SUNDRY NOTICES AND REPORTS ON WELLS

Lion Federal #1

Mack Energy Corporation
Lion Federal #1 30-015-35438 Sec. 14 T21S R21E

**Permanent Abandonment of Federal Wells
Conditions of Approval**

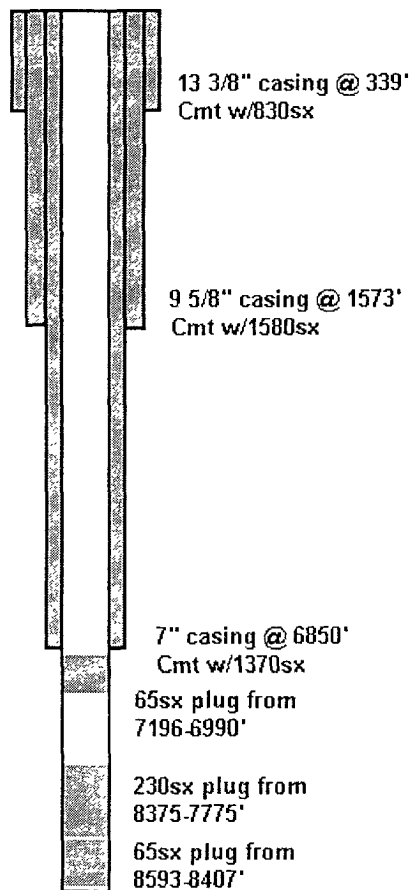
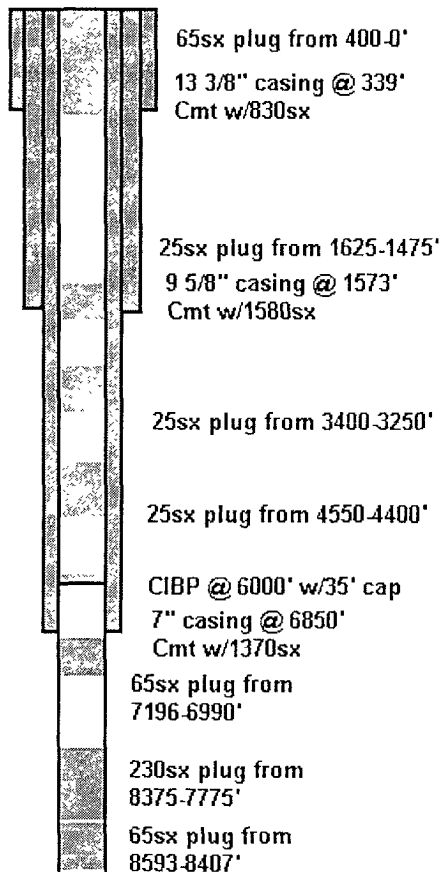
- 1) Set CIBP @ 6000' w/ 35' cmt cap.
- 2) Set 25sx cmt plug at ~~4550-4400'~~ 4746' - 4606' (Wolfcamp)
- 3) Set 25sx cmt plug at ~~3400-3250'~~ 3553' - 3423' (Abo)
- 4) Set 25sx cmt plug at 1625'-1475', WOC tag (across 9 5/8" csg shoe)
- 5) Set 65sx cmt plug from 400' to surface
